Technical Service Information

THM 4T60-E

NEW DESIGN PUMP AND ROTOR FOR 1994 MODELS

Figure 1
AUTOMATIC TRANSMISSION SERVICE GROUP

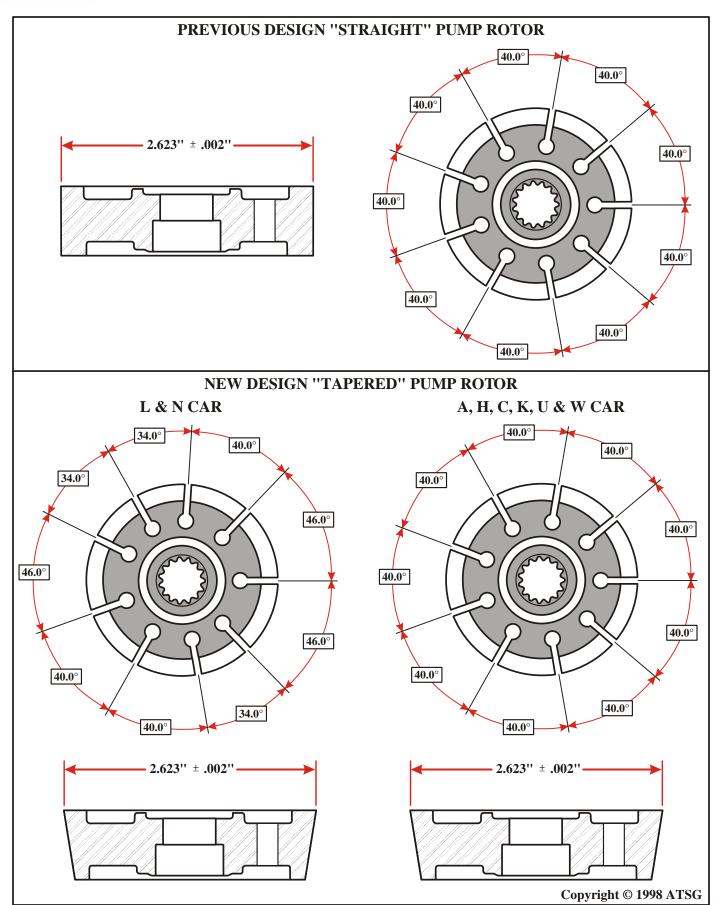
CHANGE: Beginning at the start of production for 1994 models, all THM 4T60-E transaxles were produced with a new design "Tapered" pump rotor and new design pump casting with location changes for the suction passage. Refer to Figures 1 and 2.

- (1) PUMP ROTOR New design is now "Tapered" instead of the previous straight rotor, as shown in Figure 1. The "L" Body and "N" Body vehicles were built using the random spacing of the rotor vanes (34°, 40° and 46°) similar to the 4L60-E design. All other models will use a "Tapered" rotor with equal spacing of the rotor vanes (40°) as shown in Figure 1. All slides, rotors and vanes are still selective sizes.
- (2) PUMP BODY The new design pump body for the tapered rotor has the suction slot in the pump pocket re-sized and moved closer to the center hole for the oil pump drive shaft as shown in Figure 2.

The new design tapered rotor will retro-fit back in all models of the 4T60-E transaxle.

Figure 2
AUTOMATIC TRANSMISSION SERVICE GROUP

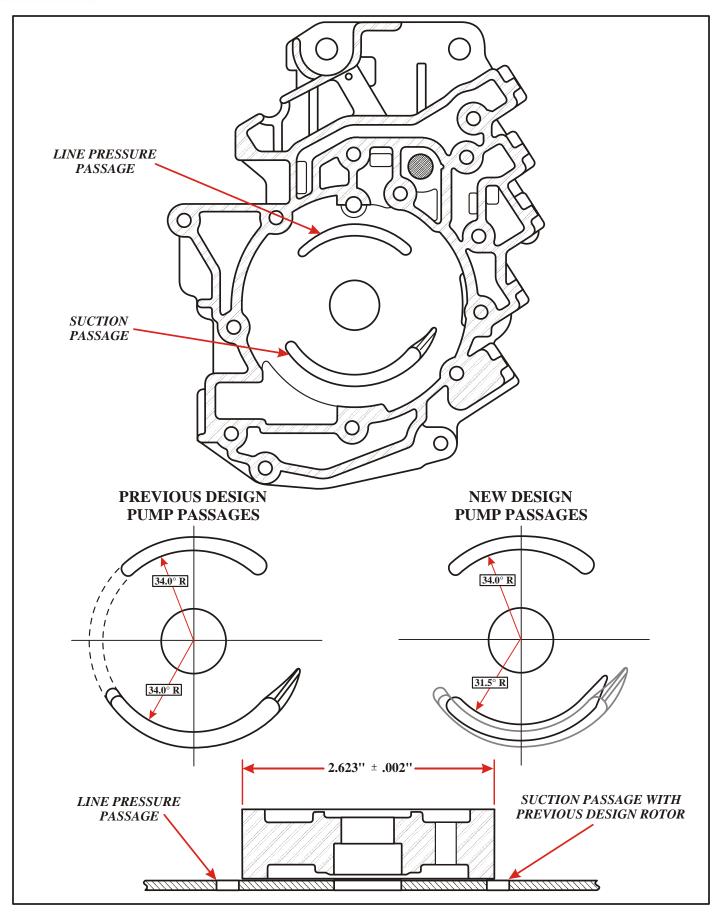
The new design pump body *must* be used with the tapered rotor because of the new location of the suction slot in the pump pocket. If the previous design (Straight) pump rotor is used in the new design casting, the rotor will cover a portion of the suction slot (See Figure 2).

The new design pump assembly as a package, will also back service all models of the 4T60-E.
